SYDNEY INTERNATIONAL CONVENTION, EXHIBITION AND ENTERTAINMENT PRECINCT (SICEEP)

TRAFFIC AND TRANSPORT ASSESSMENT ADDENDUM REPORT – SSD 5752

Traffic and Transport Assessment Addendum Report

Date 27 June 2013

Figure 1

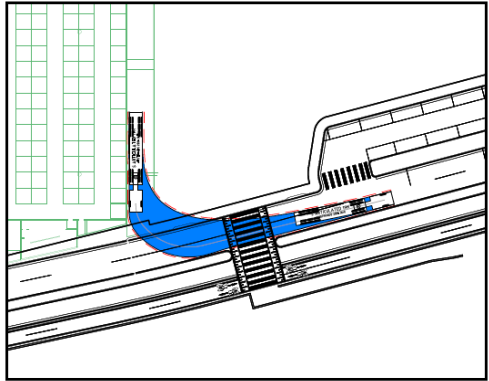
Category	Item	Issue Description	Response and Relevant Section of Addendum Report (where applicable)
Traffic Impacts	1	<p>The geographic coverage of the model is insufficient to demonstrate that the critical intersections assessed in the model will operate at a satisfactory level. It is therefore recommended that all upstream intersections are modelled to ensure the traffic approach profiles are correctly represented at the critical intersections.</p>	<p>Originally the geographic coverage of the AIMSUN Micro-simulation model was determined by Mott MacDonald as part of assessing the SICEEP development proposal. Hyder carried forward the AIMSUN model and updated it to support the environmental assessment of the SICEEP project. Hyder has re-assessed the geographic coverage of the SICEEP for modelling purpose and found that the modelling study area coverage is fit for the study purpose.</p> <p>Figure 1 below shows key SICEEP development footprint and modelling study area coverage.</p>  <p>Legend</p> <ul style="list-style-type: none"> Development Car Park Study Area Key Development Traffic Movements Key Intersections

Category	Item	Issue Description	Response and Relevant Section of Addendum Report (where applicable)
			<p>The following factors were considered in determining the adequacy of the geographic coverage:</p> <ol style="list-style-type: none"> 1. Future Traffic distribution to and from SICEEP i.e., <ul style="list-style-type: none"> • North-south movement to and from the development has been captured by Darling Drive/Murray Street and Darling Drive/Ultimo Road intersections. • East-west movement to and from the development has been captured by Darling Drive/Pier Street and Harbour Street/Goulburn Street/Pier Street intersections. • North-south movement to and from the development has been captured by Harbour Street and Hay Street. 2. Potential impact locations. <p>In general road network impact from the SICEEP will decline with greater distance from the site. Additional traffic impact from SICEEP will be largely confined within the boundary of the modelling study area (see Figure 1)</p>

Figure 1 Existing and Proposed Bus Network

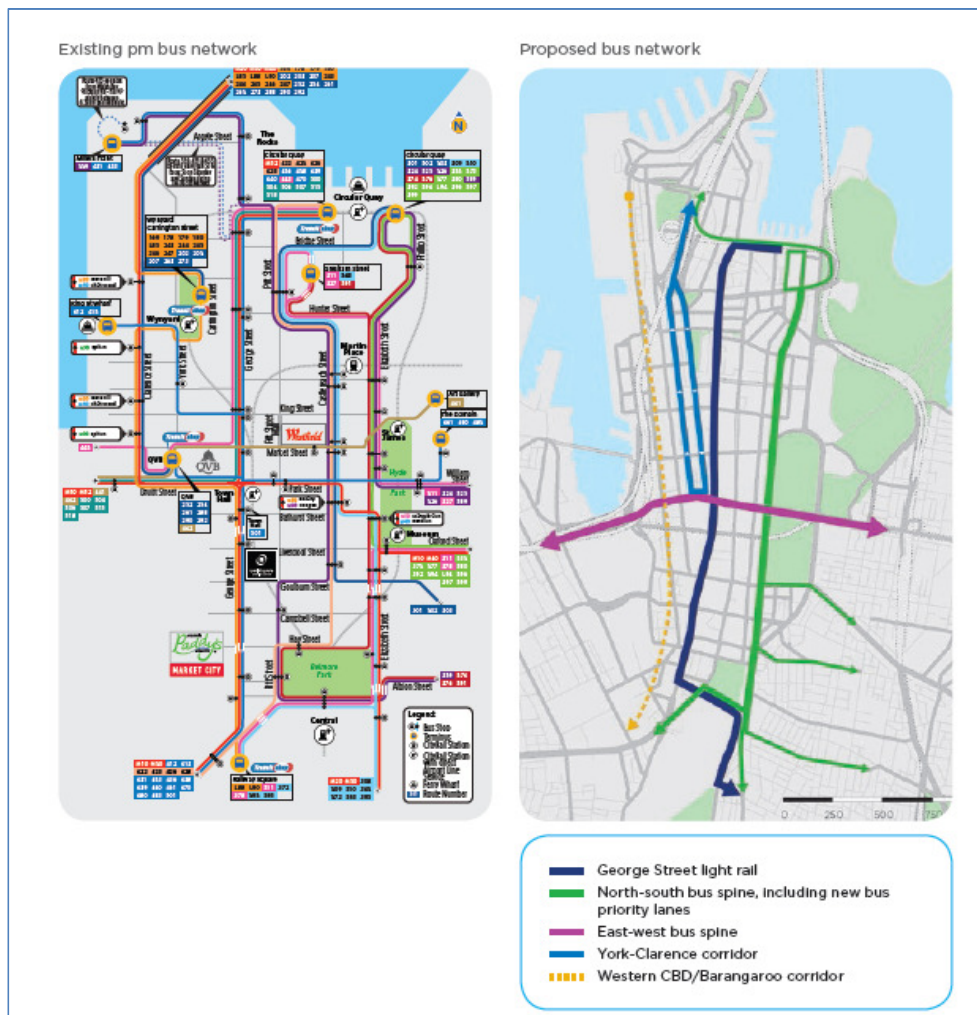
Category	Item	Issue Description	Response and Relevant Section of Addendum Report (where applicable)
Public Transport	9	Clarify the provision for future public bus transport to service the precinct in consultation with Transport for NSW.	<p>DHL has consulted with Transport for NSW (City Transport Planning) on potential provisions for future bus transport service to the precinct. TfNSW confirmed a study is underway to investigate a Bus Servicing Strategy for the CBD. TfNSW is unable to provide any further information until an announcement is made by government as to a preferred CBD Bus Plan in conjunction with the proposal for the George St Light Rail system.</p> <p>Section 3.4 of this Addendum Report provides preliminary information on new bus routes in the CBD.</p> <p>DHL commit to undertake further consultation with NSW Bus and Coach Association to ensure any future requirements are considered.</p>

Figure 1 shows the initial bus network concept for the CBD suggests a western CBD bus corridor closer to the SICEEP site. The main north south bus route will be on Elizabeth Street and the main east-west bus routes will be on Park Street and Druiitt Street. However, this bus route plan is deemed to be preliminary and the preferred bus plan will only be confirmed after the completion of the ongoing investigations. Nevertheless, TfNSW have indicated that Harbour Street and Darling Drive are flagged as potential future bus service routes and provisions for future bus facilities can be considered. The current Darling Drive realignment proposal considers a bus stop in the south adjacent to the Theatre and in the north adjacent to the Convention Centre, and proposed hotel.
